Technical Bulletin TB No. AA-08098 No Revision

Bell Helicopter Vibration Monitor (BHVM) Kit
P/N 412-262-001* / 412-262-002*
*with SmartCycle+ Interface Kit installed,
P/N 412-261-006

**Bell Helicopter Vibration Monitor (BHVM) Kit with
SmartCycle+ P/N 412-262-003 / 412-262-004**

Bell Helicopter Textron model 412 and 412EP
helicopters with subject BHVM with SmartCycle+
installed in accordance with STC SR09373RC-D.

FIGURE 1 SOFTWARE VERSION DECAL

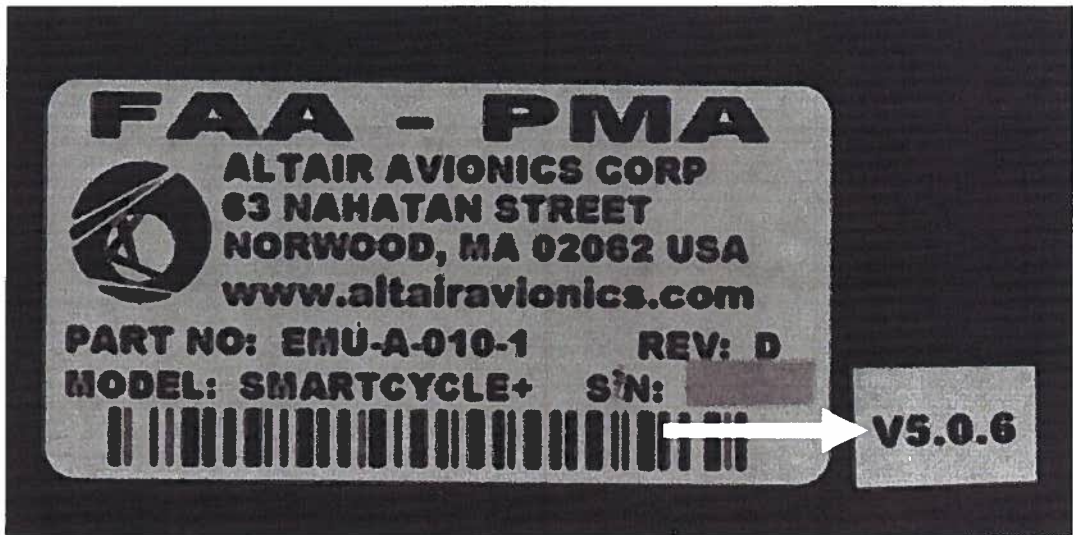
1. Locate the decal on the processor denoting the software version (Refer to Figure 1).
2. If the software version is V5.0.6, no further action is required. If the software version is V5.0.0 to V5.0.5, the processor can be returned for upgrade.

FIGURE 2 MONITOR LINK PROGRAM, MLU STATUS

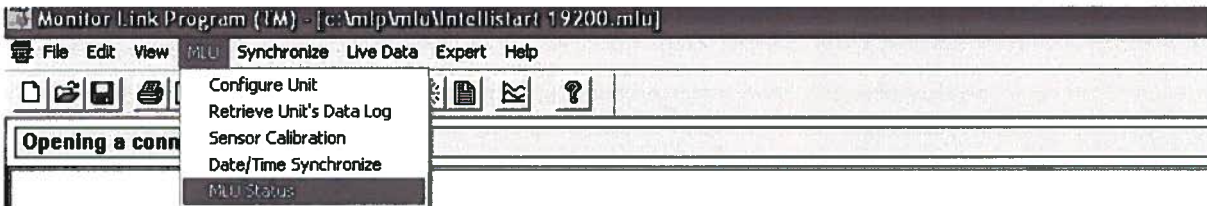
4. Open the Monitor Link Program on the laptop and select Edit> Communication Port >Autodetect.
5. Once communication has been detected, on the tool bar select MLU> MLU Status (Refer to Figure 2).

6. Note the software version displayed on the top of the screen.
7. If the software version is V5.0.6, no further action is required. If the software version is V5.0.0 to V5.0.5, the processor can be returned for upgrade.
